RE: Jimmy Johns
Devils Lake, ND
Addendum No. 1 – Mechanical Items
MBN Project No. 26-155

Sheet Name:
PLUMBING PLANS

M100

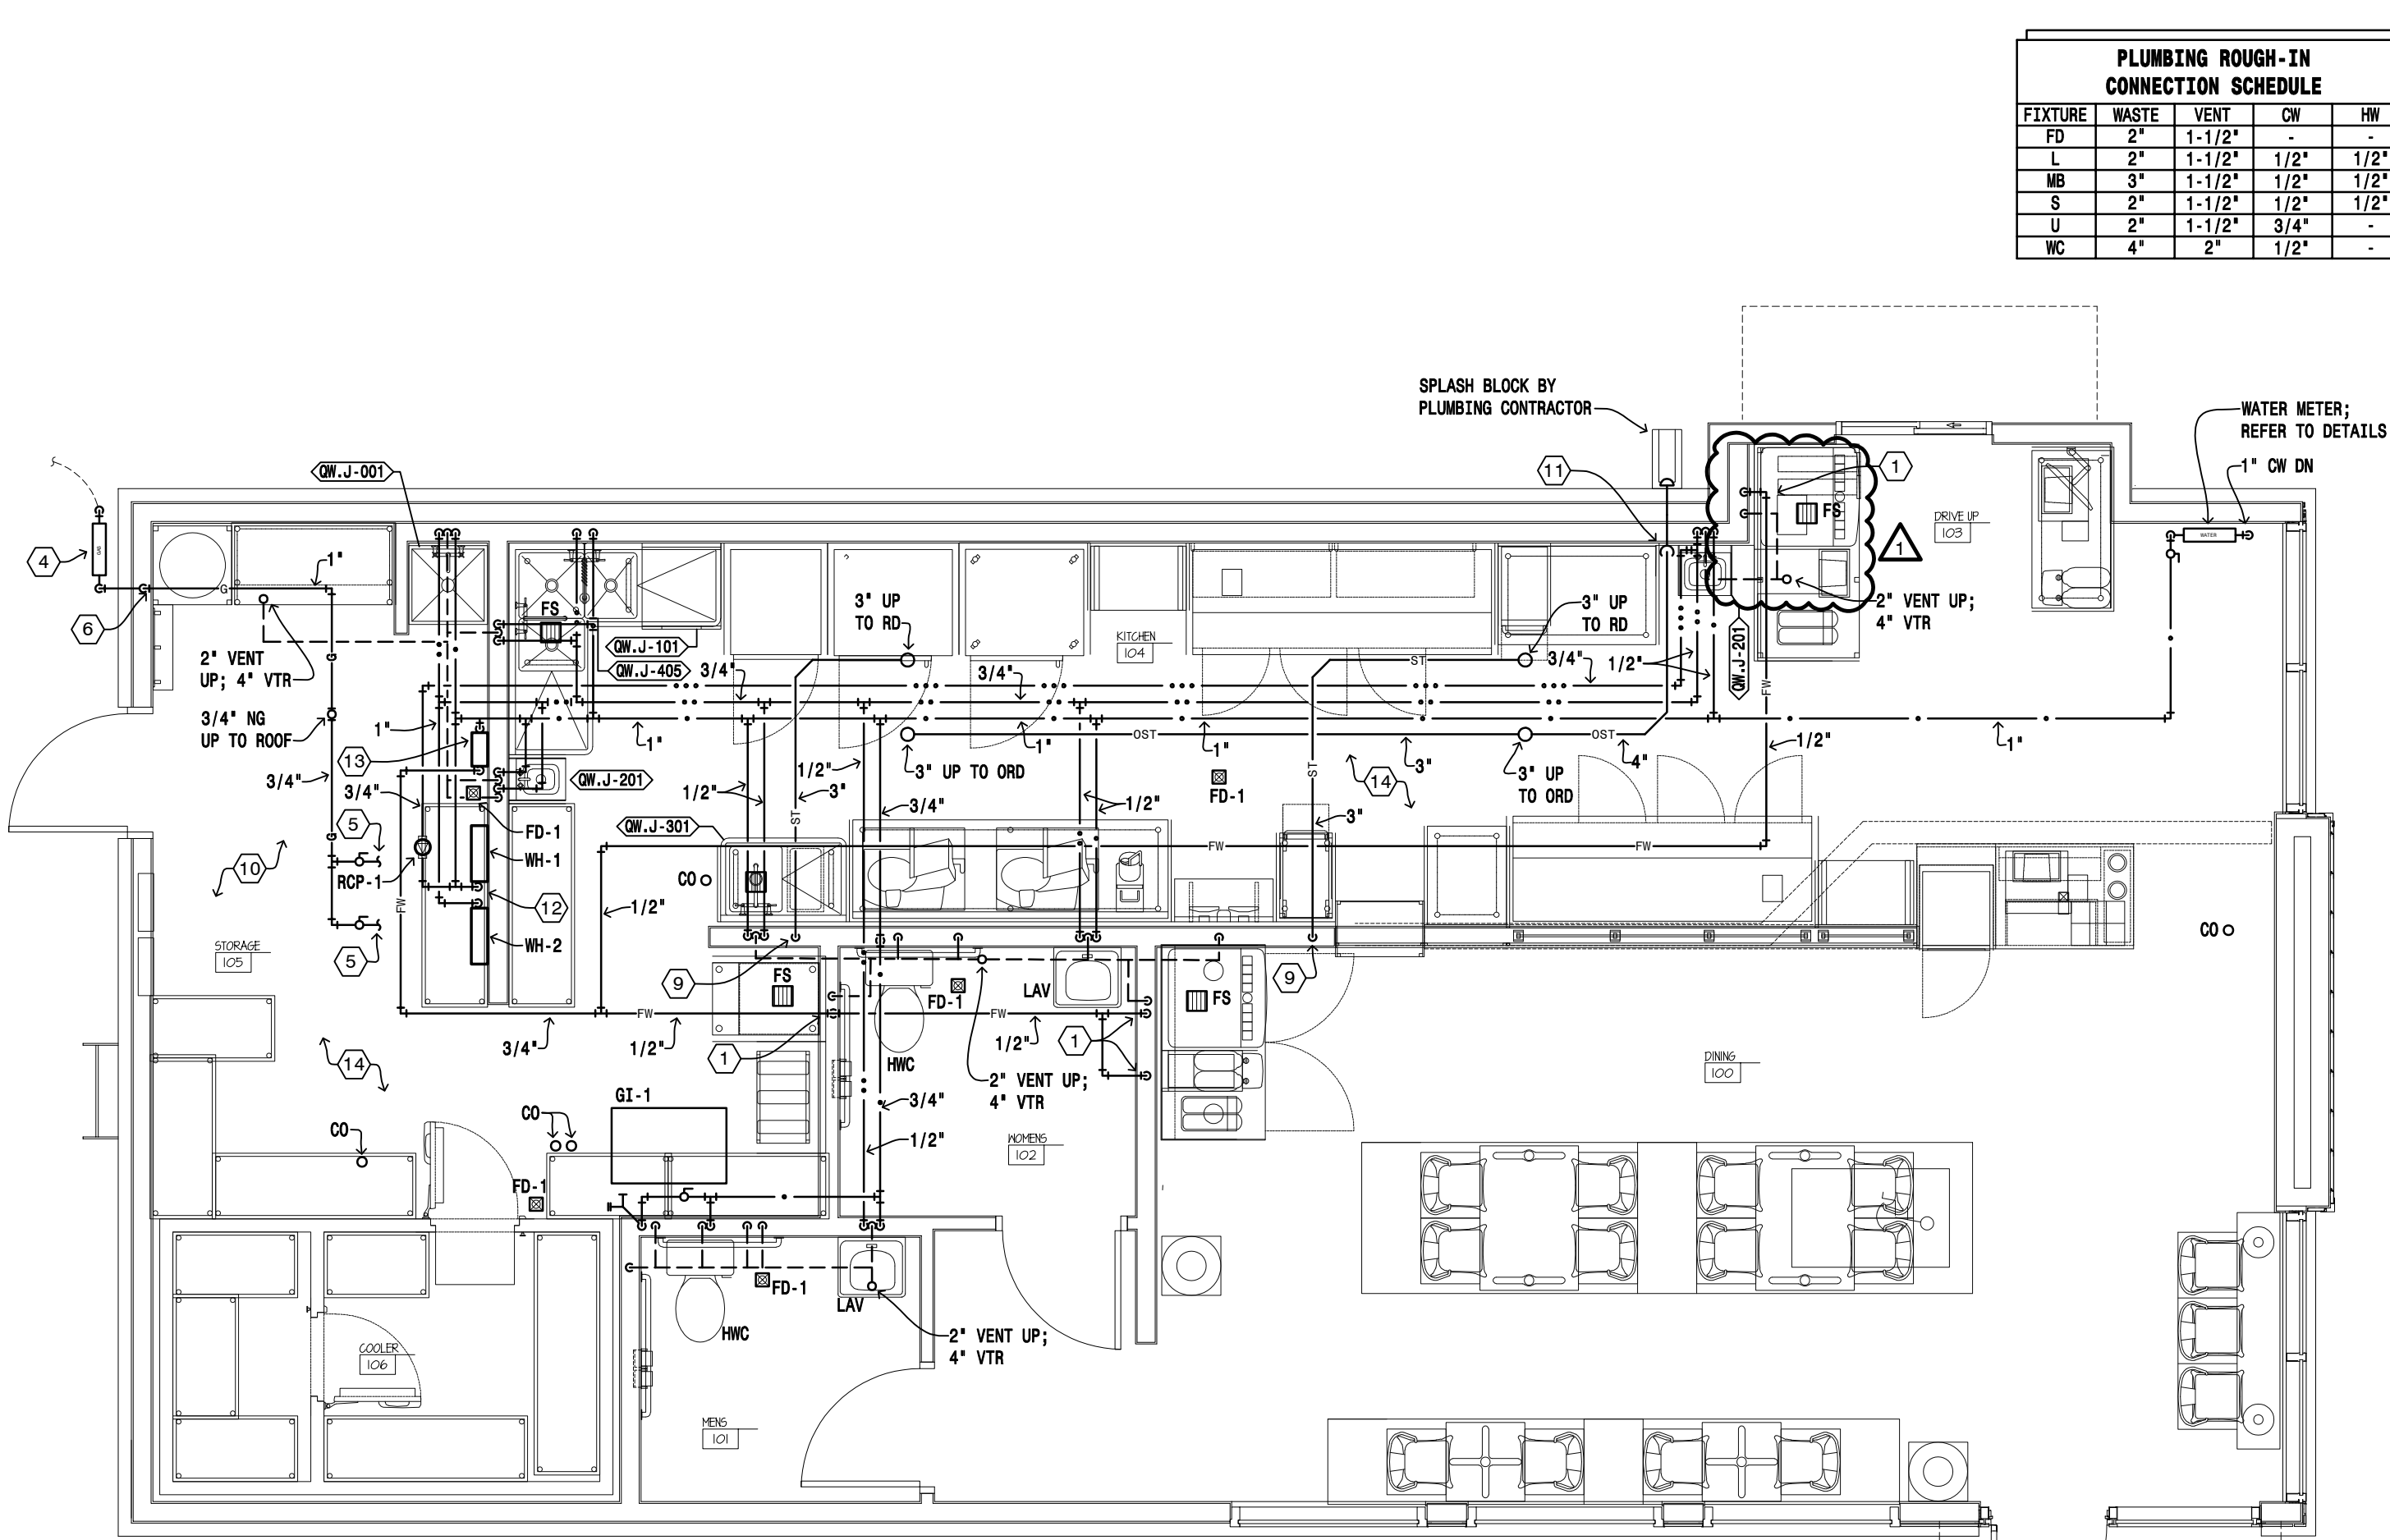
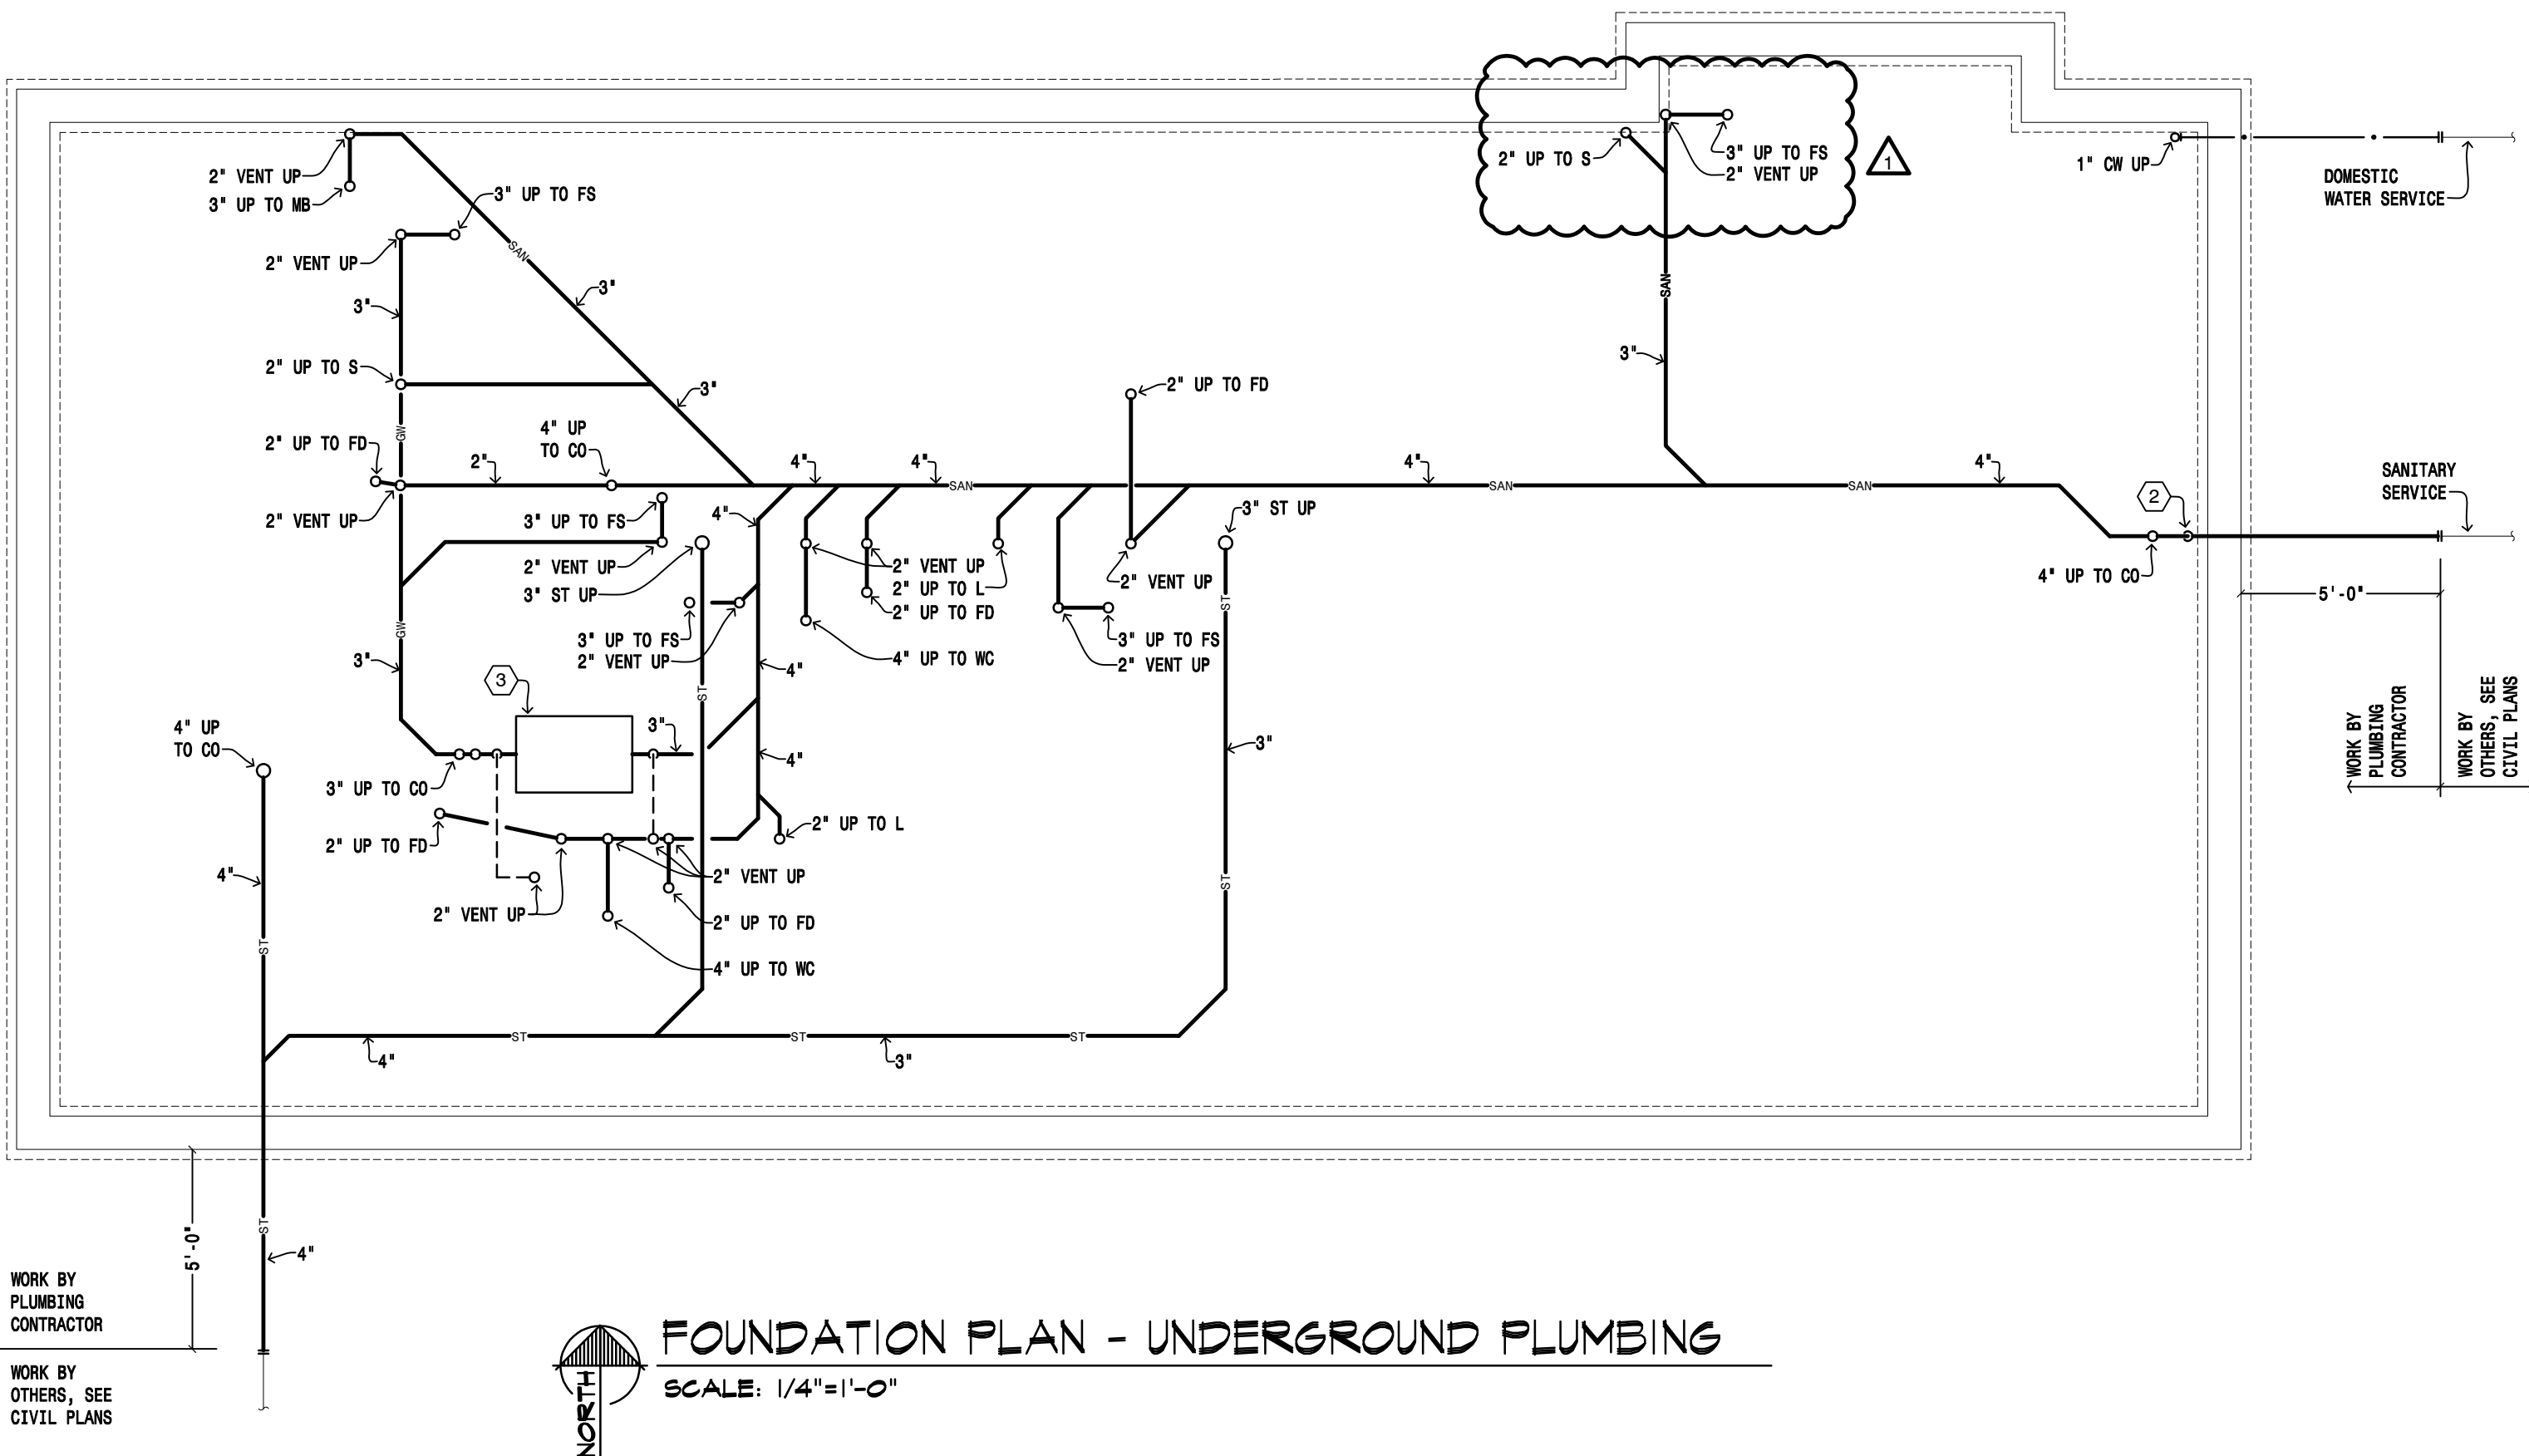
M100 Plumbing Plans: see attached sheet for addition of floor sink.
